SUBJECT: NRC SPECIAL INSPECTION REPORT 05000247/2000-010
STEAM GENERATOR TUBE FAILURE

Indian Point 2 Nuclear Power Plant
NRC Inspection Report 05000247/2000-010

IR 05000247-00-010, March 7 thru July 20, 2000; Consolidated Edison of New York, Inc.; Indian Point Unit 2; Special Team Inspection reviewing the causes for the February 15, 2000, steam generator tube failure, in accordance with NRC Inspection Procedure 93812. Findings in steam generator eddy current test examination program corrective actions and technique qualification.

REFERENCED FIGURES **5 thru 8** - Eddy Current Inspection -Tube R2C5 in SG24

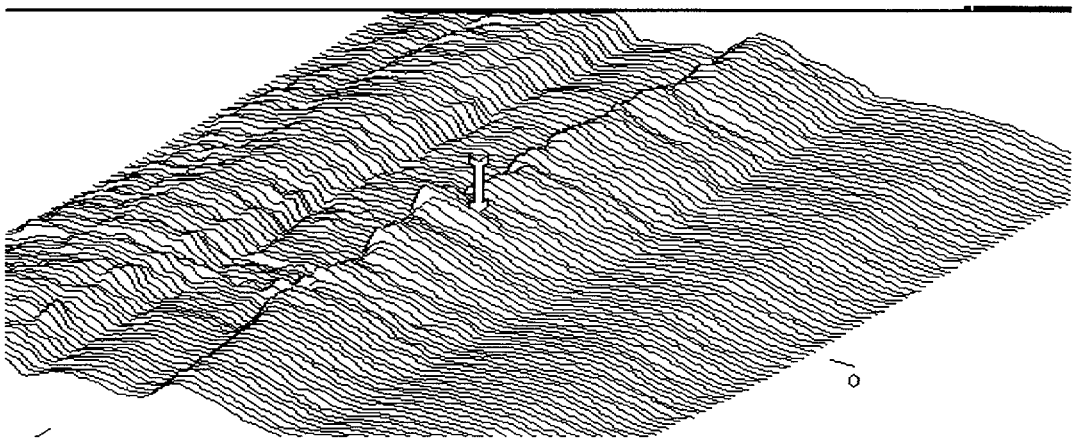
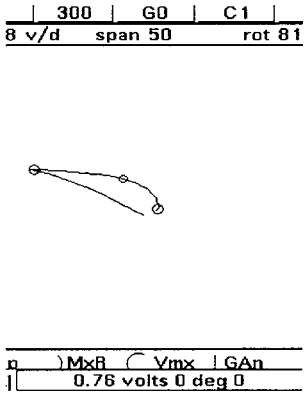
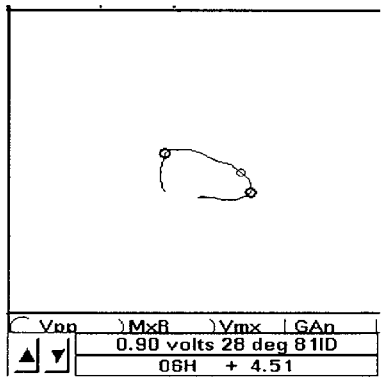
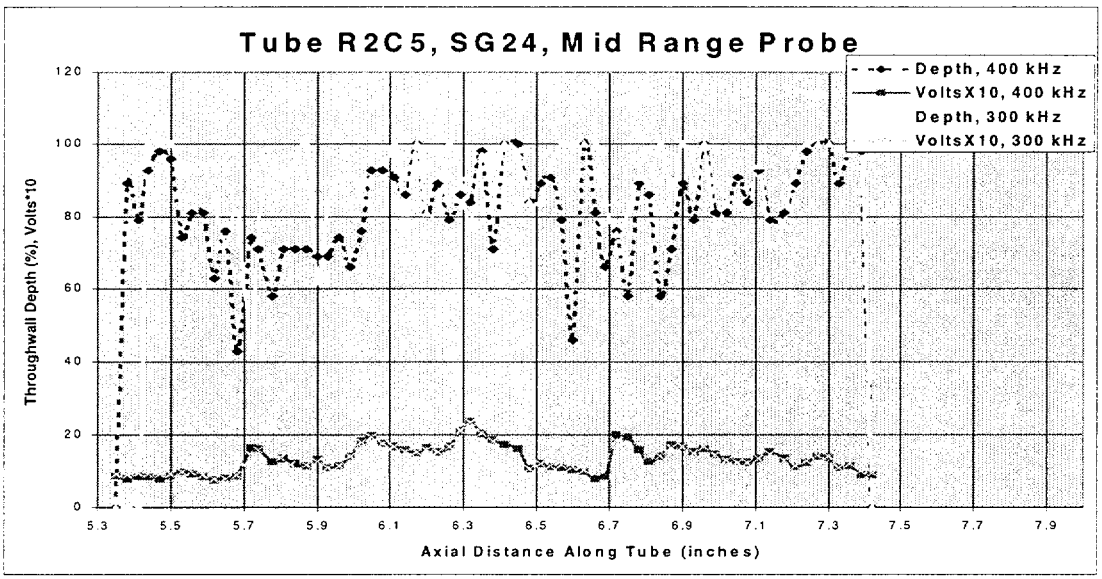
1. R2C5 in SG 24 - Figure 5 is a c-scan plot of the vertical component of the ECT voltage signal. The defect signal, indicated by the arrow, sits on a noise ridge that runs the length of the tube. This noise ridge is about 1-volt in amplitude and measures as a deep ID defect. This ridge makes both the detection and sizing of this defect more difficult. Figures 6 and 7 are the lissajous plots for the flaw area and the noise ridge, respectively. These figures show that a flaw signal is distinguishable from the characteristic noise signal, as was the case in the other tubes profiled. No year 2000 data is available since the tube failed.

The indication has been profiled for both the 300- and 400-kHz inspection frequencies, as is shown in Figure 4. The signal-to-noise ratio is slightly better for the 400-kHz frequency than for the 300-kHz . The voltage above 1.2-volts indicates the defect; however, there is considerable noise. The depth estimate based on 1997 data is 87-percent TW.

REFERENCED FIGURES - **9 thru 11 -** Eddy Current Inspection - Tube R2C69 in SG 24

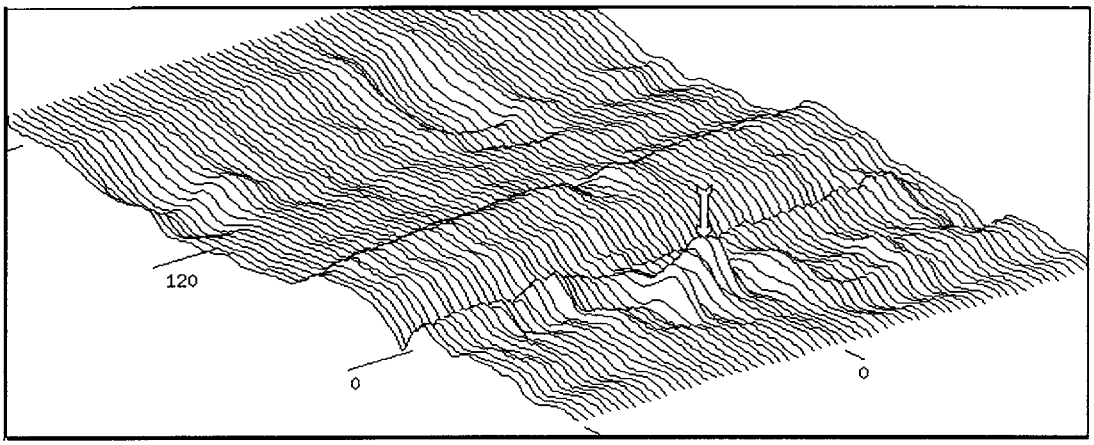
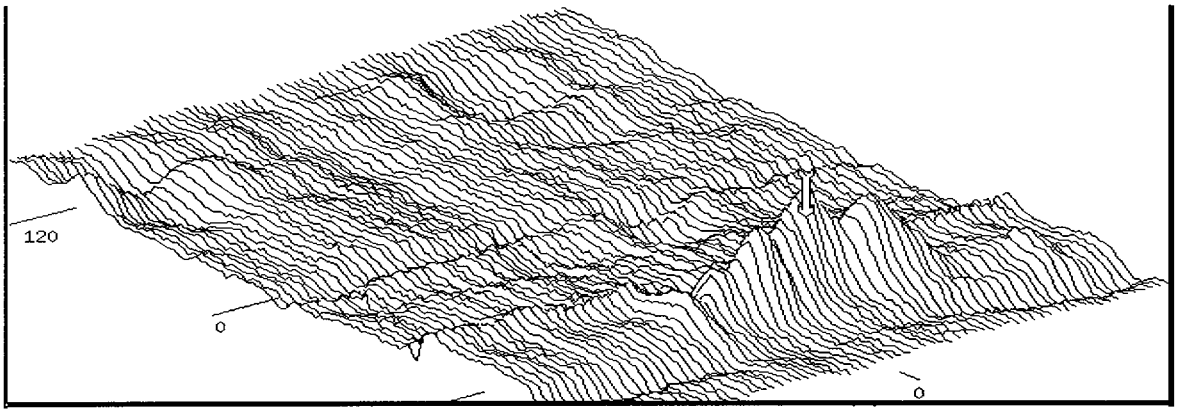
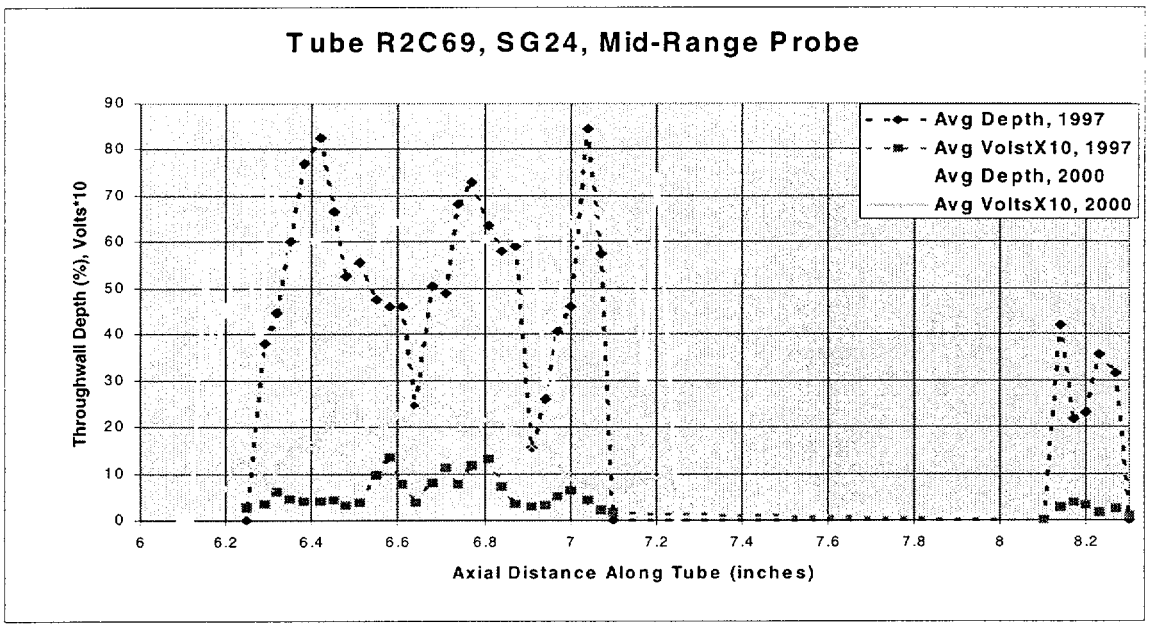
2. R2C69 in SG 24 - Figure 9 shows the c-scan plot for the 1997 data. There is considerable noise present. For comparison, the c-scan plot for the 2000 data is included as Figure 10. The noise features between the 1997 and 2000 data are similar enough to verify that this is the same defect at the same location. Figure 11 shows the profile. The defect voltage is only about 1 volt, and there is a considerable amount of noise on the tube, relative to the defect signal. The depth estimate based on 1997 data is 52.6-percent TW.

REFERENCED FIGURES **12 thru -14 -** Eddy Current Inspection Tube R2C72 in SG 24

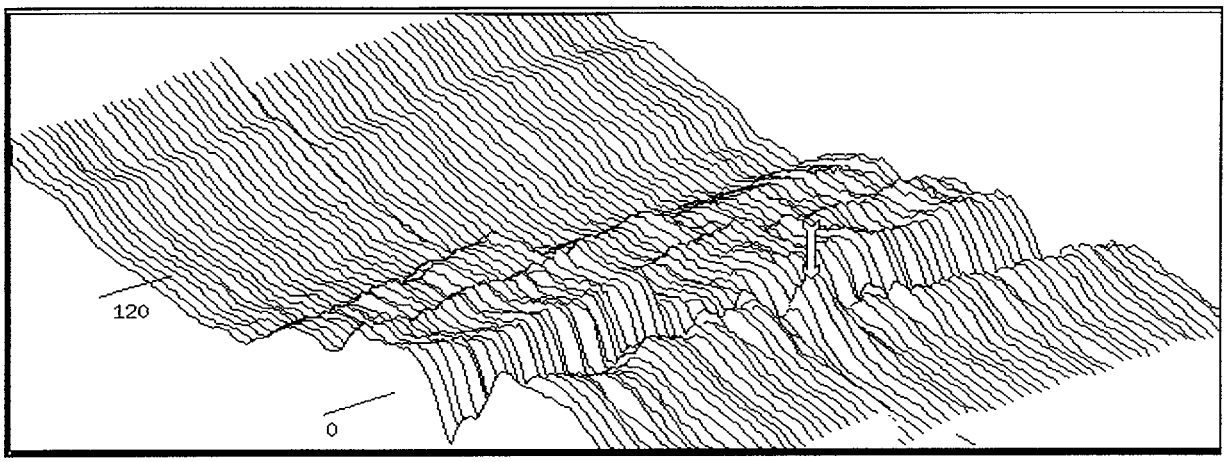
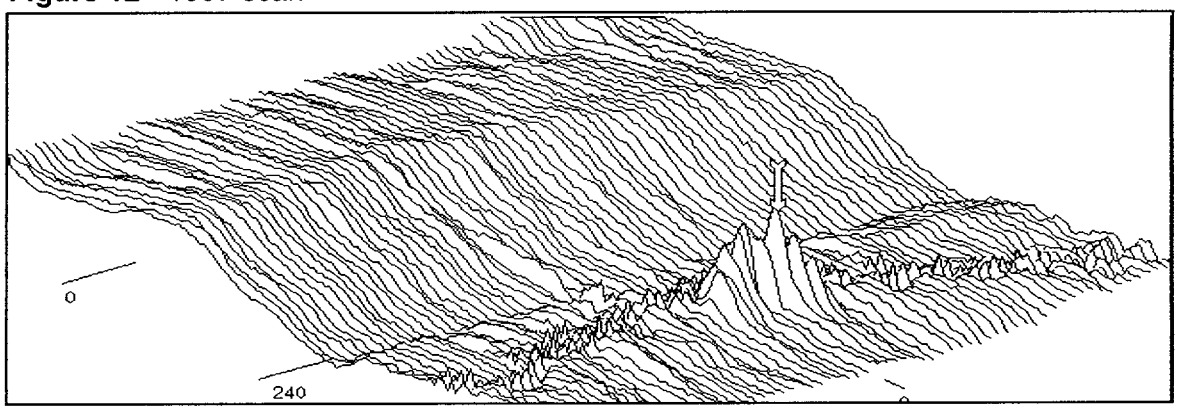
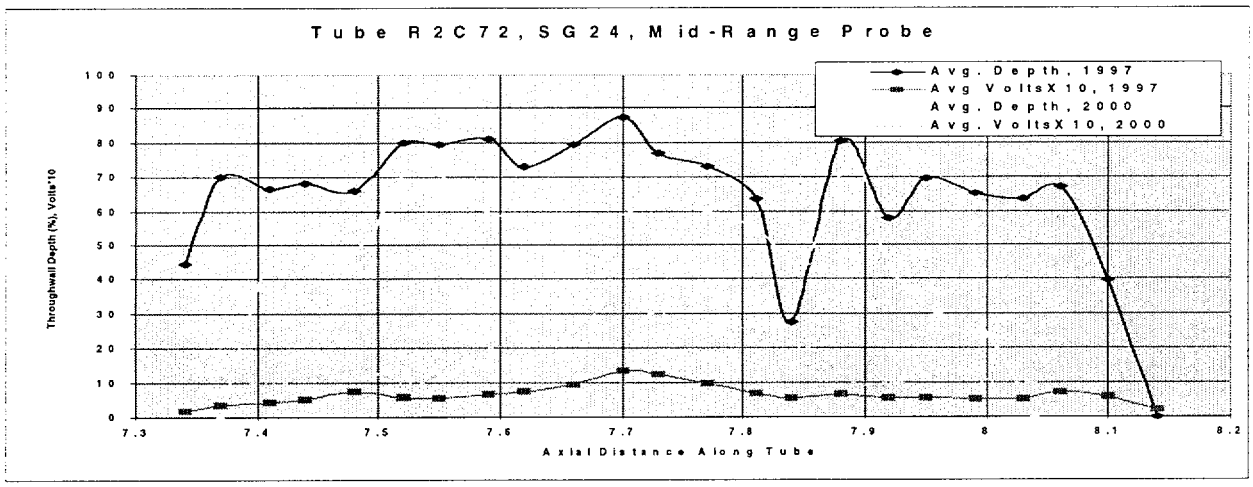
3. R2C72 in SG 24 - Figure 12 shows the c-scan plot of the 1997 data. There is considerable noise present. The crack is sitting in a ridge of noise and barely extends above a ridge of deposits. For comparison, the c-scan plot for the 2000 data is included as Figure 13. Figure 14 shows the profile. The crack barely extends above a 1-volt amplitude for a short length, and this is the only part of the crack that can be profiled reliably. The depth estimate based on 1997 data is 79.2-percent TW.

REFERENCED FIGURES **15 thru 17 -** Eddy Current Inspection- Tube R2C87 in SG 21

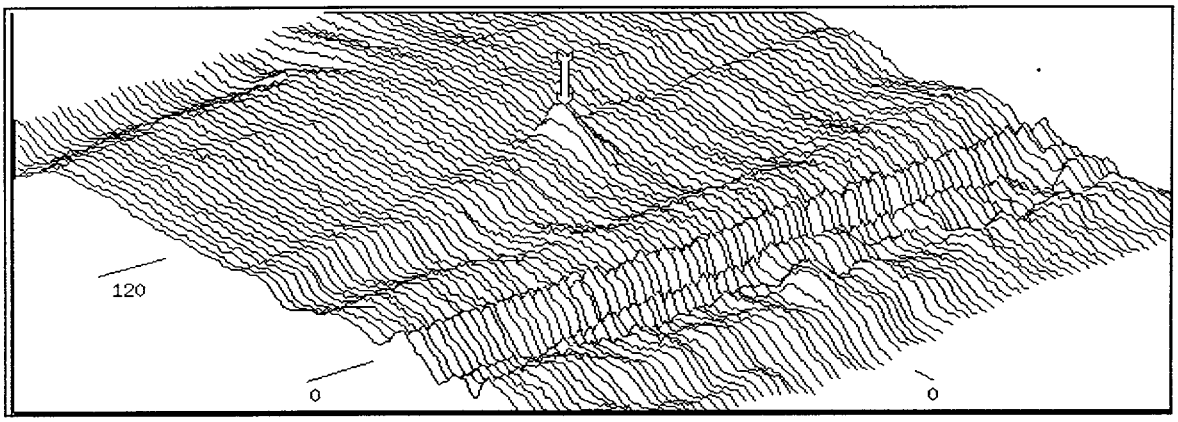
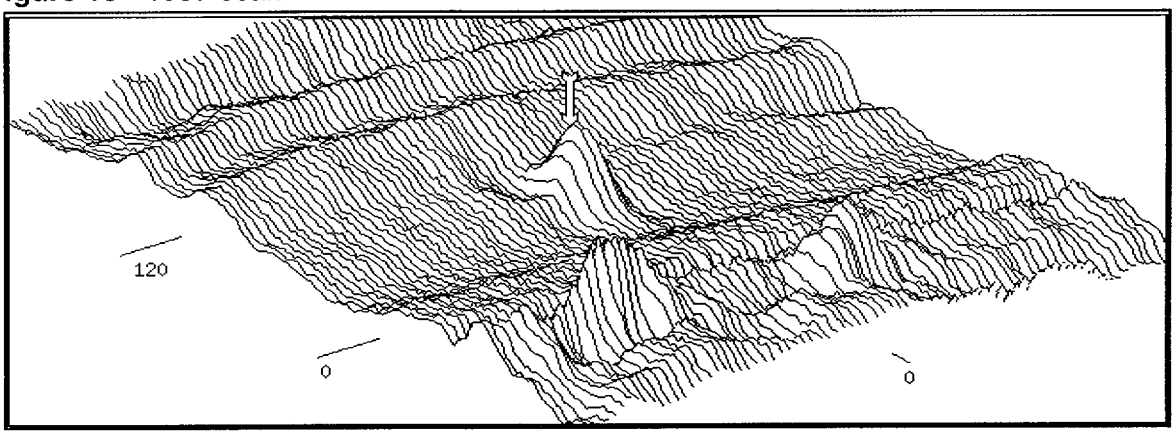
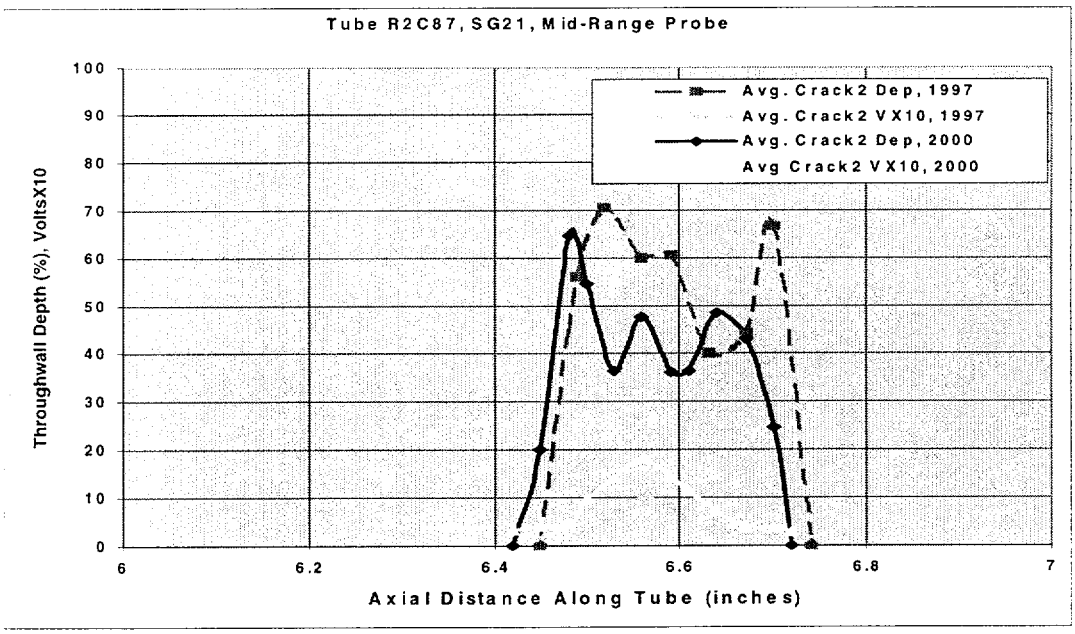
4. R2C87 in SG 21 - this tube was identified as having several cracks. Figure 15 shows the c-scan plot of the 1997 data. The most prominent crack is sitting in a relatively clean area of the tube. For comparison, the c-scan plot for the 2000 data is included as Figure 16. Figure 17 shows the profile of the most prominent crack. The depth estimate based on 1997 data is 63.7-percent TW.

REFERENCED FIGURES **18 and 19** - Eddy Current Inspection- Tube R2C67 in SG 24

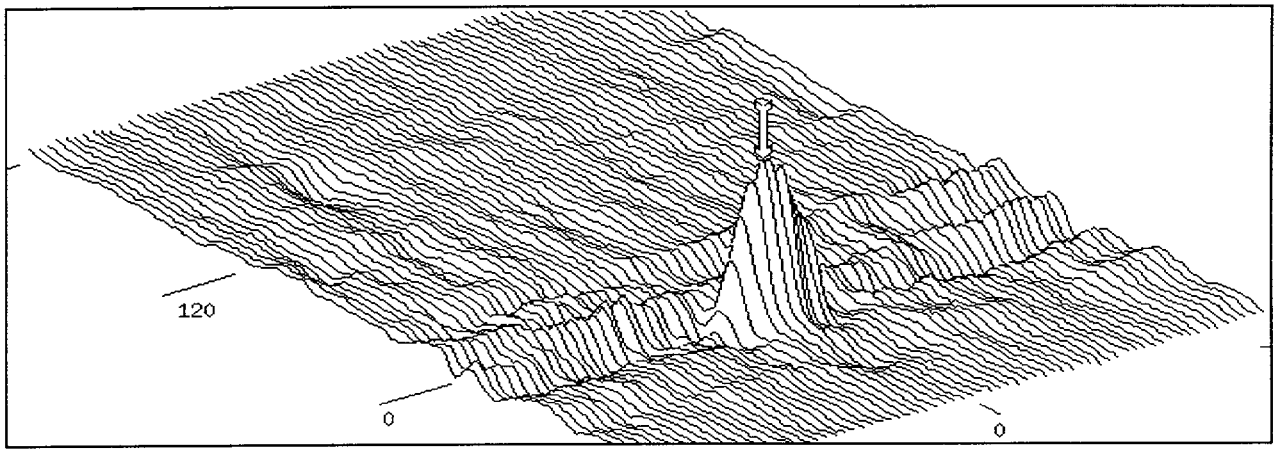
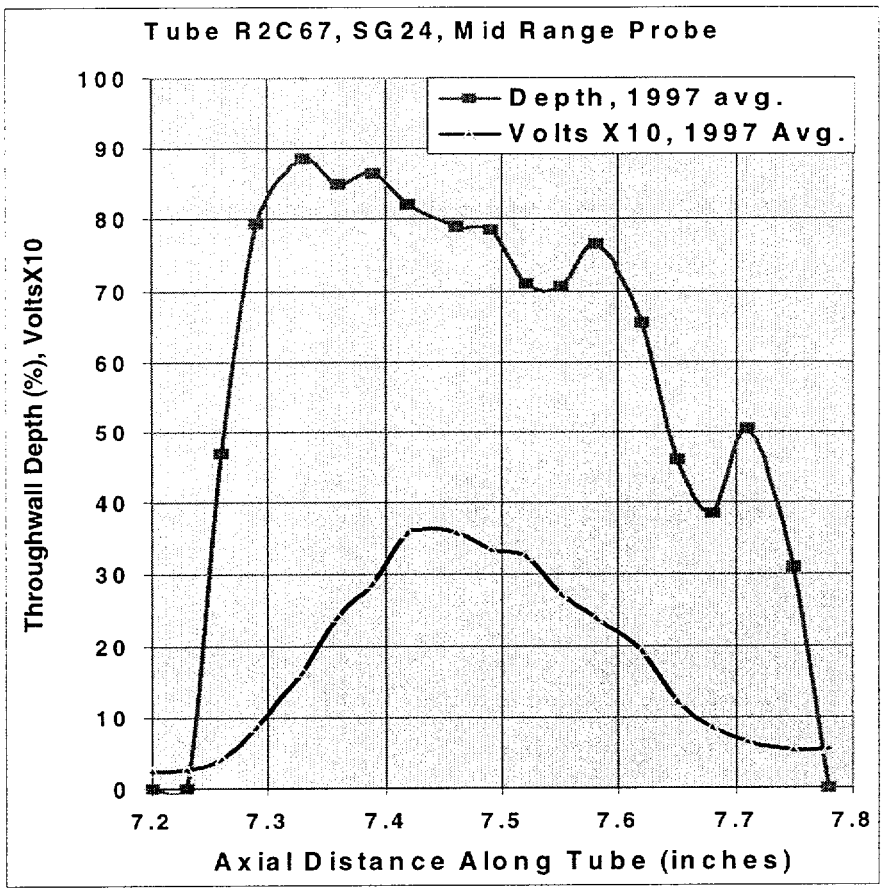
The c-scan plot of the 1997 data from R2C67 is shown in Figure 18. The crack sits beside a ridge, in a valley, and is in an easily detectable portion of the tube. The large amplitude of the voltage signal, in relation to the standard calibration notch, would indicate that this is a "mature" crack. No year 2000 data is available since the tube was plugged in 1997. Figure 19 shows the profile. The depth estimate based on 1997 data is 87.5-percent TW.

While the flaw was identified and the tube plugged, neither Con Edison nor its ECT contractor recognized the discovery of the low-row U-bend apex indication as a significant condition adverse to quality and did not enter the issue into its corrective action program. Identification of this flaw was significant, because it was the first observation of this type of degradation in the U-bend area in SG tubes at Indian Point 2. There was no specific review as to the significance of this flaw or the possible extent of the condition.
